JPB CAC
CORRESPONDENCE
AS OF
June 17, 2025

From: [Roland Lebrun](#)
To: [Public Comment](#)
Cc: [Board \(@caltrain.com\)](#); [cacsecretary \[@caltrain.com\]](#); [SFCTA CAC](#)
Subject: Board Board Budget Workshop item 5 Public Comment
Date: Wednesday, May 28, 2025 4:18:28 PM
Attachments: [Business case for 4-car EMU trainsets.pdf](#)
[Business case for Battery-electric locomotives.pdf](#)

From: [Roland Lebrun](#)
To: [Public Comment](#)
Cc: [Board \(@caltrain.com\)](#); [cassecretary \(@caltrain.com\)](#); [SFCTA CAC](#)
Subject: Item 9 Guadalupe River Bridge Replacement
Date: Wednesday, June 4, 2025 2:58:00 AM
Attachments: [image.png](#)
[image.png](#)
[Guadalupe River Bridge alternative proposal.pdf](#)
[Drawing TT-D4004.pdf](#)

From: [Roland Lebrun](#)
To: City.clerk@sanjoseca.gov
Cc: [Board \(@caltrain.com\)](#); [cacsecretary \(@caltrain.com\)](#); [Caltrain, Bac \(@caltrain.com\)](#)
Subject: City Council Item 2.27 At-Grade Station Alternative and Diridon Program
Date: Tuesday, June 10, 2025 4:06:15 AM
Attachments: [Item 2.27 Diridon City Council June 10 2025.pdf](#)

CAPACITY INCREASE

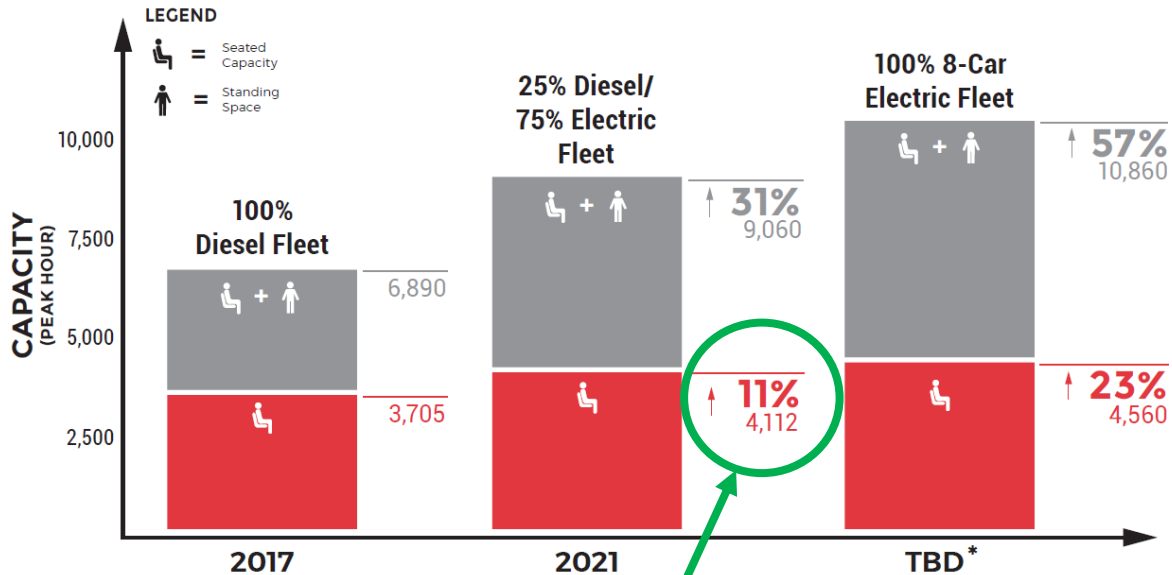
Please refer to the EMU seating capacity chart on the next page and consider the following challenges & opportunities:

- Staff's current proposal to operate six 656-seat 7-car EMUs during peak cannot possibly meet the requirements of the FFGA (6x656= 3,936).
- Current ridership (and associated farebox recovery) cannot possibly sustain the permanent operation of 7-car trainsets.
- 4-car trainsets can be coupled into 8-car consists during peak and special events.
- 4-car trainsets open an opportunity to negotiate a single conductor per trainset with the unions (one conductor for a 4-car consist, two conductors for an 8-car consist).
- Flexible 4-car/8-car operations based on demand can potentially yield:
 - o a 30% annual saving in O&M (\$25M in FY25).
 - o a 30% reduction in power consumption (\$6M in FY25).

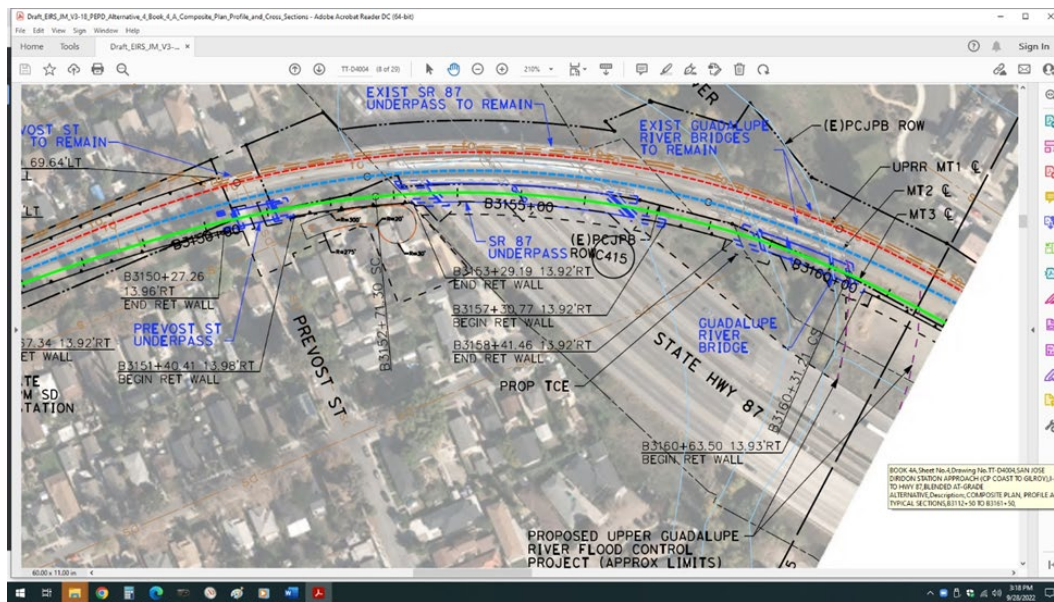
Page 2 "*The project as currently envisioned proposes to replace one bridge (MT-1) and extend the other one (MT-2) by 110 feet. Given the current funding shortfall, it is unclear why Caltrain should prioritize a bridge (MT-1) that (contrary to assertions by Caltrain's Interim Executive Director) is rarely used by Caltrain and will never be electrified.*"

Issues with the current project

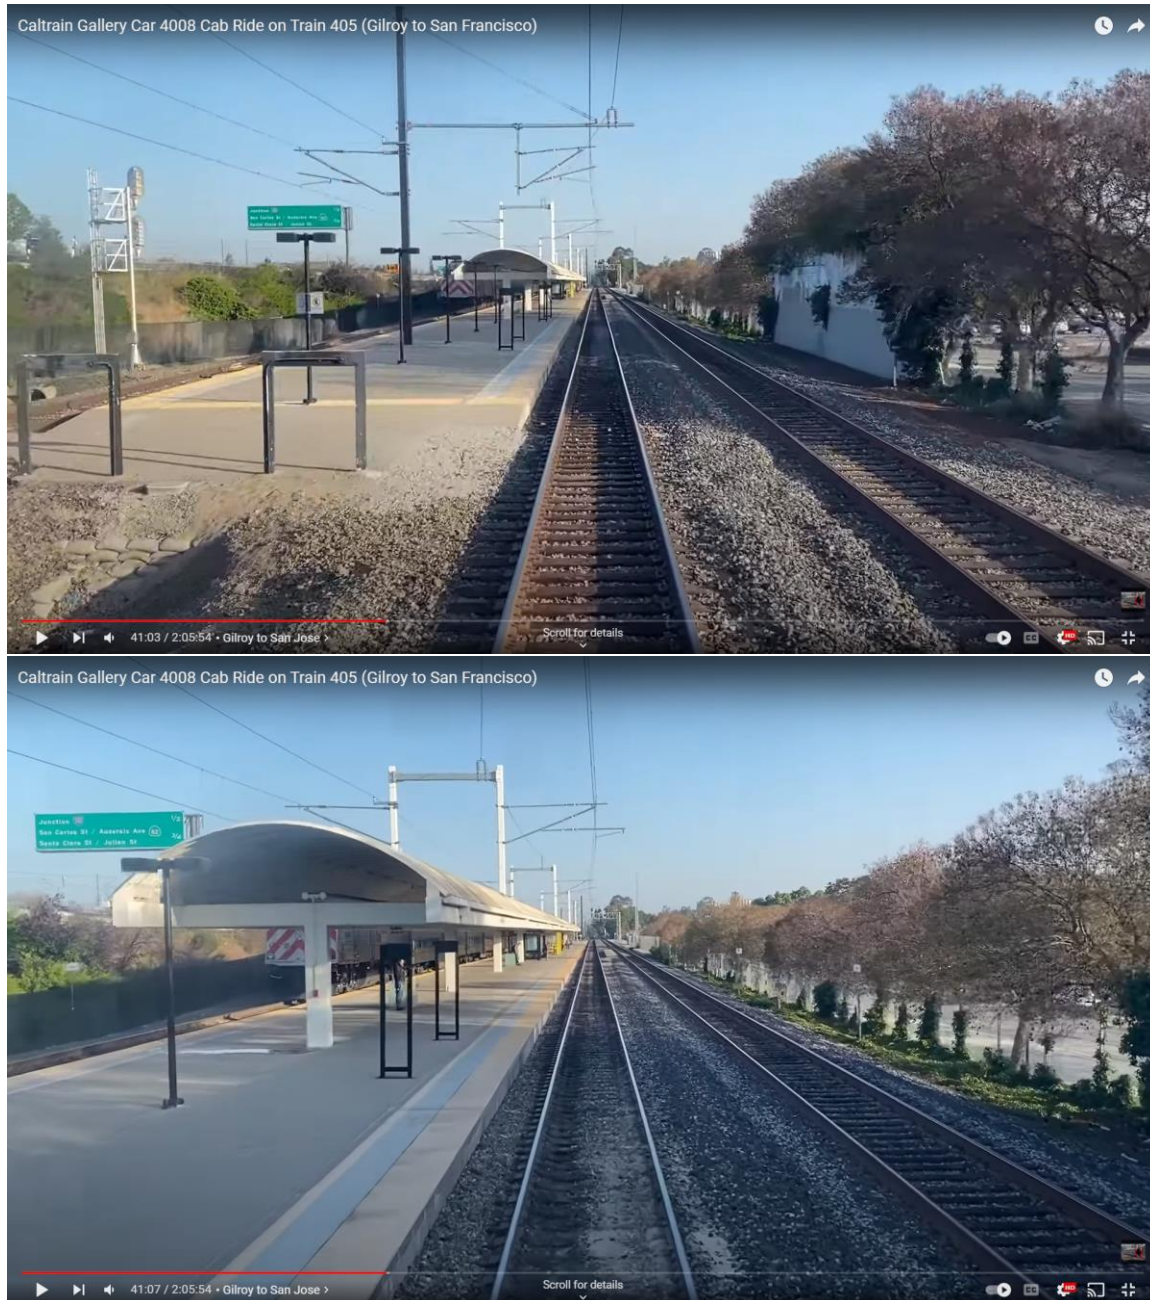
The project as currently envisioned proposes to replace one bridge (**MT-1**) and extend the other one (**MT-2**) by 110 feet. Given the current funding shortfall, **it is unclear why Caltrain should prioritize a bridge (**MT-1**) that (contrary to assertions by Caltrain's Interim Executive Director) is rarely used by Caltrain and will never be electrified.**

Phased alternative

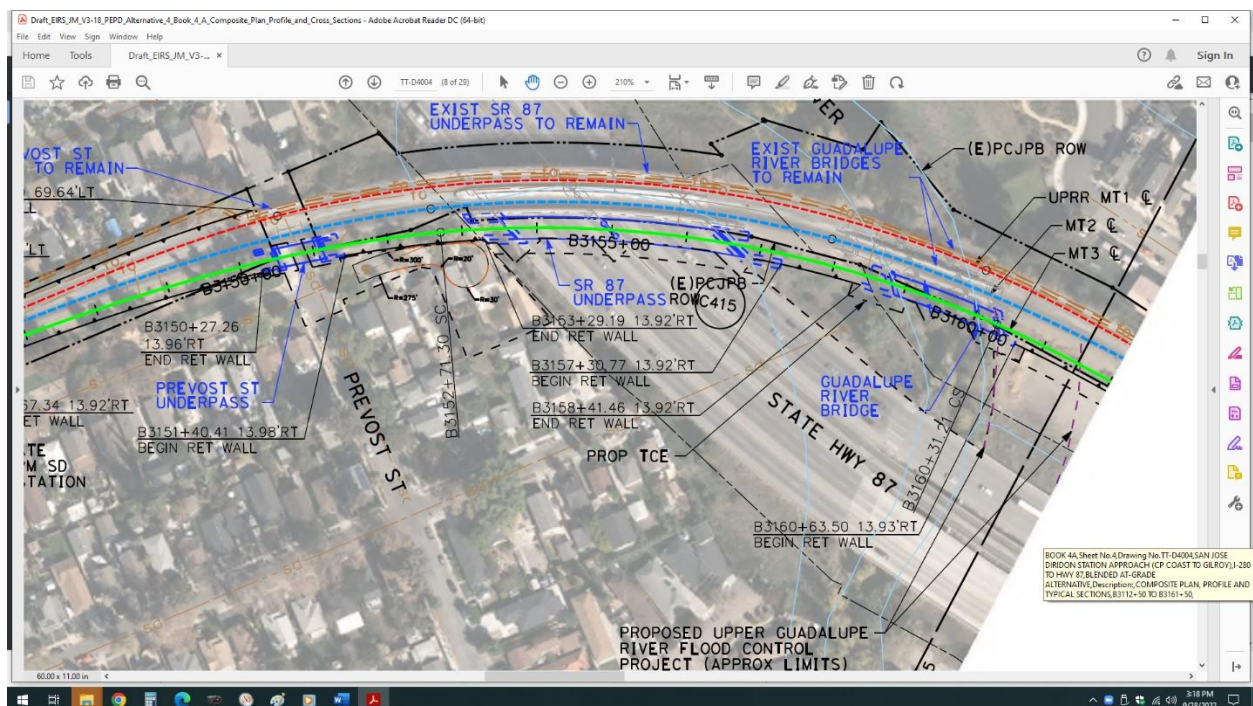
Another approach could be to leverage the current funding envelope to prioritize the future **MT-3** bridge environmentally cleared in the Merced to San Jose EIR and delay the reconstruction of the **MT-1** & **MT-2** bridges until funding is available. Access to the **MT-3** bridge would be provided via the addition of a switch connecting **MT-2** to **MT-3** located between Highway 87 and the Guadalupe River.

Recommendations:

- 1) Reject all bids for the Guadalupe River bridge replacement project as currently proposed.**
- 2) Advance the engineering for the **MT-3** bridge (San Jose to Merced EIR drawing number TT-D4004 attached for your convenience).
- 3) Solicit bids for the **MT-3** bridge including the **MT-2** to **MT-3** switch and the extension of **MT-3** to Tamien platform #2.
- 4) Re-issue bids for **MT-1** & **MT-2** bridge replacements when funding has been secured.

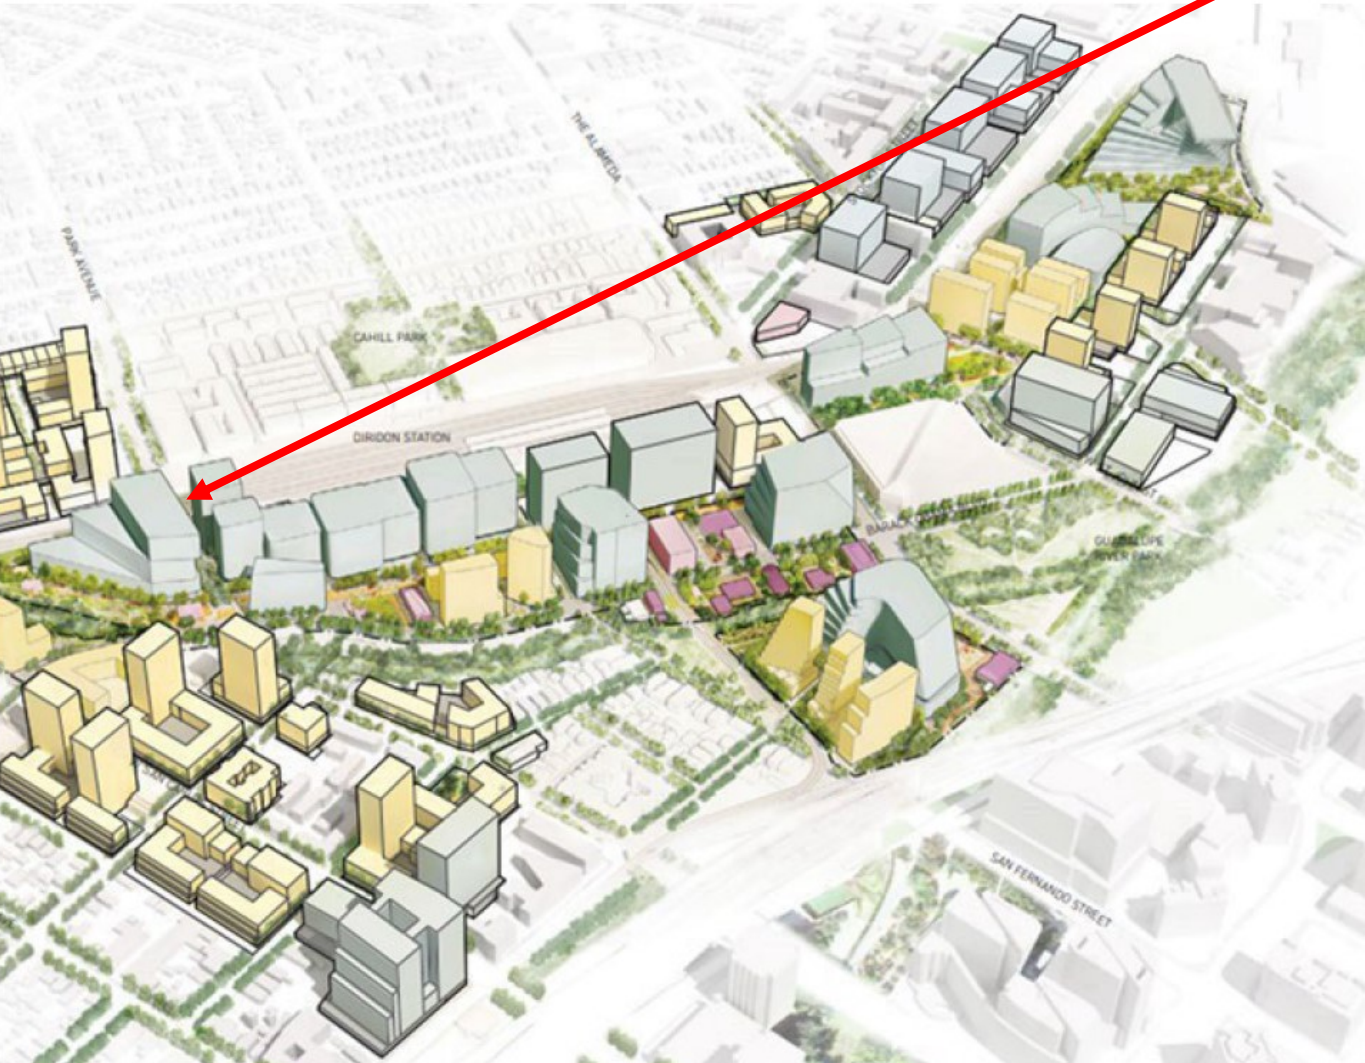
The regrading of Downtown West moves the entire station 20 feet below the creek embankment

The Paseo de San Fernando “Big Dip” conflicts with the light rail alignment

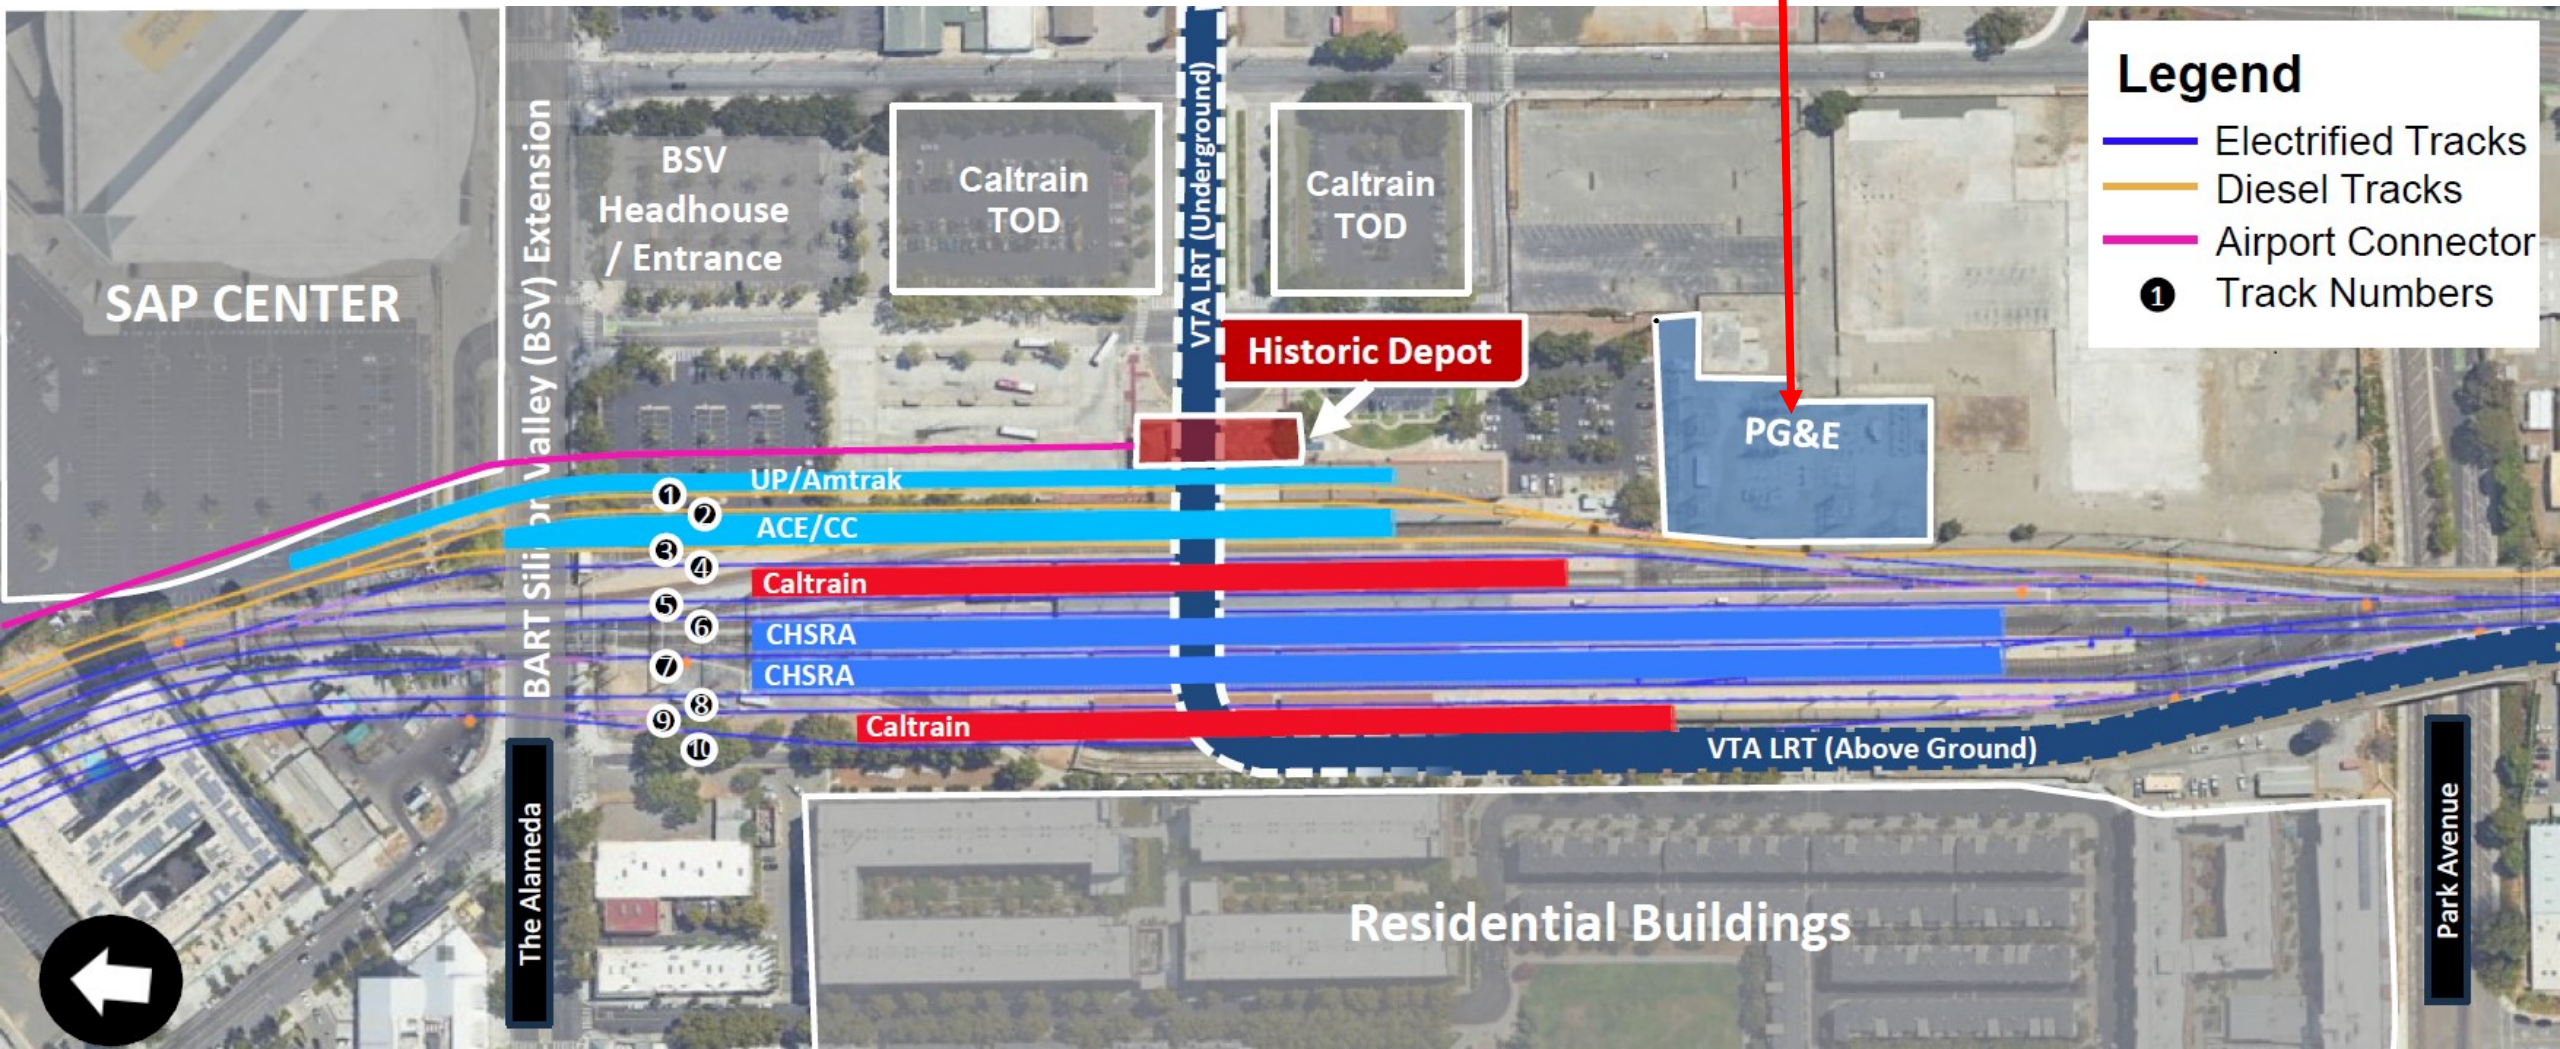
Designing around the existing PG&E substation resulted in shifting the station platforms one block too far north
